## BTeV Corrector Update 031218

**Draft note: Superconducting Multipole Corrector for BTeV, V. S. Kashikhin, TD-03-049**

## Flat Coil Array

Fig. 1 General view of corrector magnet

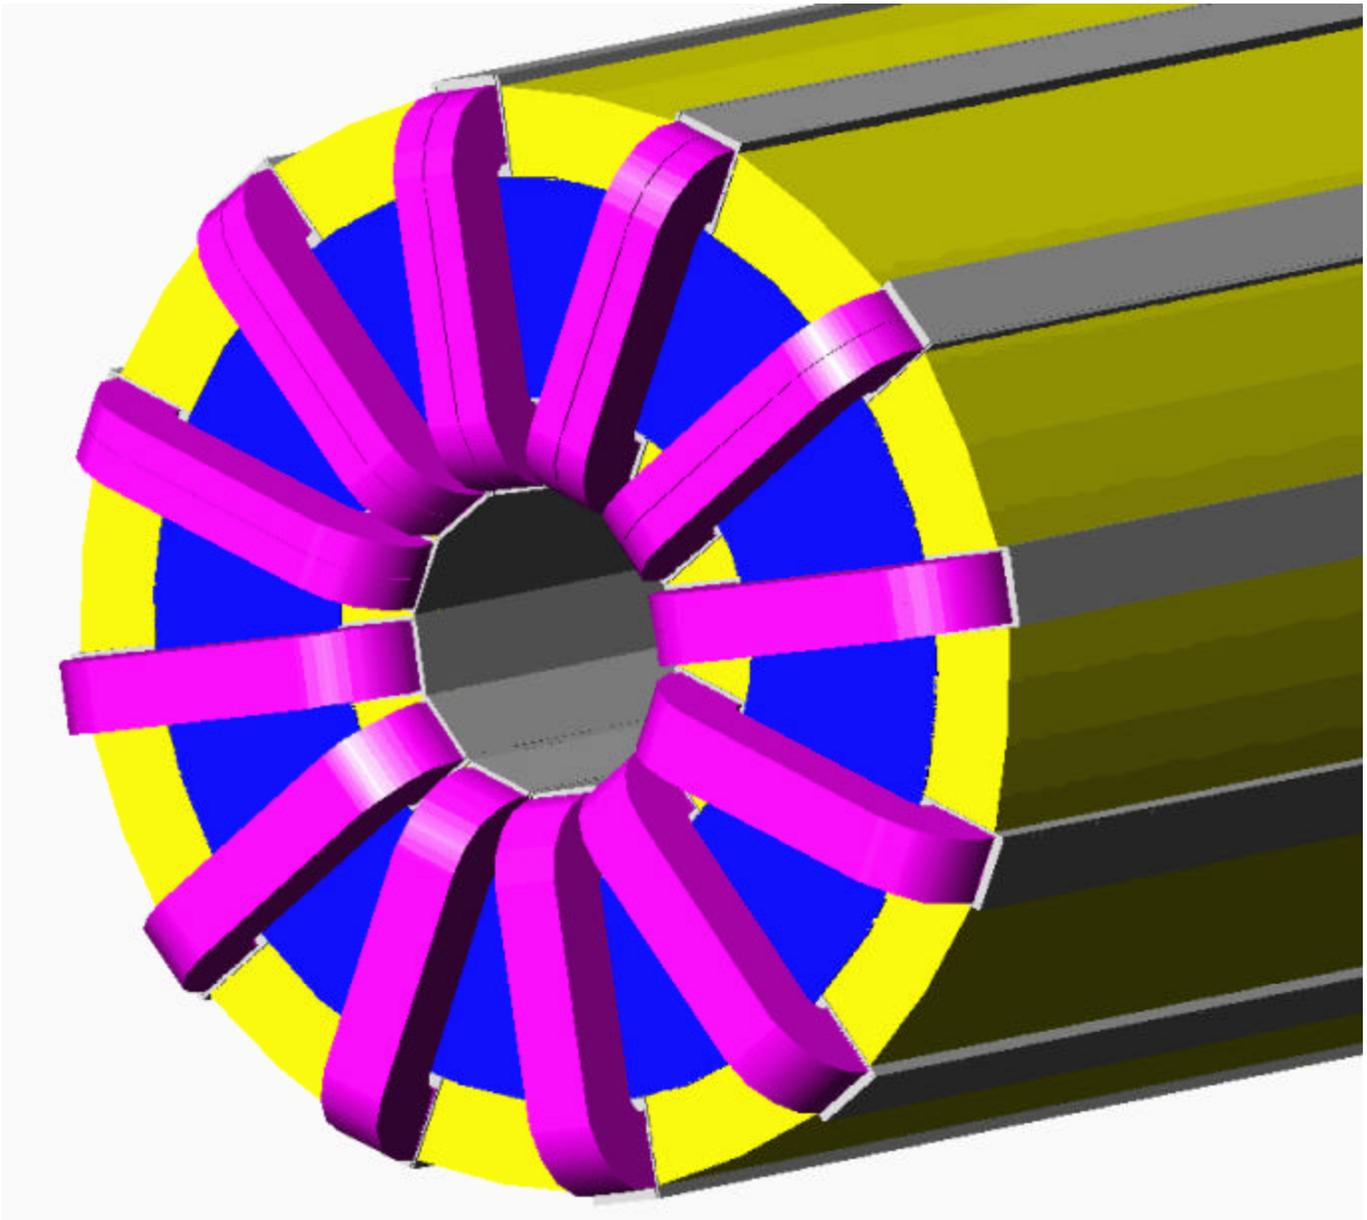
- a. I'm not too worried about the **"complexity" of powering** that Bob Kephart mentions. However, I do worry that all possible current configurations are taken into account for quench margin and mechanical stability (for quenching and field quality) under the various coil pack to coil pack force directions for all of the powering configurations

- b. I do not know what the **field quality** will be. It will not be as good as the cylindrical shells since there is more granularity in the coil configurations. I don't know what the field criteria will be for correctors. **And a trim quad for the LHC** (inner?) **triplet**. Is it appropriate to do a field map calculation at this time?

- c. There are **two other corrector magnet configurations needed:**
- i. **SKEW SEXTUPOLE** - easily accommodated by rotating current configurations by 30-degrees

- ii. **SKEW QUADRUPOLE** - which doesn't have a simple "pole" configuration for the flat coil array. It looks to me, doing a super-position of two attainable "pole" quadrupoles that a skew quad can be oriented as (looking down bore of quad and time on a clock)

coil	current
12:30	+0.5*I
1:30	+I
2:30	+0.5*I
3:30	-0.5*I
4:30	-I
5:30	-0.5*I
6:30	+0.5*I
7:30	+I
8:30	+0.5*I
9:30	-0.5*I
10:30	-I
11:30	-0.5*I
- d. In looking over Mike Church's spreadsheet with the needed correctors at each station, it is apparent that not all correctors are needed everywhere leading to some simplification. For example, except a the triplet spool, H and V dipoles are not needed at the same station.
- e. Would one want to include the **triplet trim quad** in this multi-powering corrector scheme or should it be separate function?

So my biggest concerns are field quality (calculations could show whether this is an issue), and quench stability under all powering configurations from both current/field/short sample and mechanical motion stability concerns.

Corrector Main Parameters

Integrated dipole field (any angle to axis), T*m	0.48
Integrated quadrupole gradient (any angle to axis), T	25
Integrated sextupole strength, T/m	450
Effective length, m	1.5
Inner coil radius, mm	40
Inner core radius, mm	63
Outer core radius, mm	120
Operational current, A	50-55
Coil number of turns	850-930
Bare strand diameter, mm	0.5
Strand diameter with insulation, mm	0.63
Coil area, mm <sup>2</sup>	368
Cold mass outer diameter, mm	290

Easily obtained by field rotation of  $45^\circ$  or magnet by  $15^\circ$ . It is also possible power coils  $0.5I$ ,  $I$ ,  $0.5I$ , ...

Field quality:  $a_4=-1.42$ ,  $a_6=-0.27$ ,  $a_8=1.08$ ,  $a_{10}=27.7$  compared to an 'allowed level' of 138.4 units.
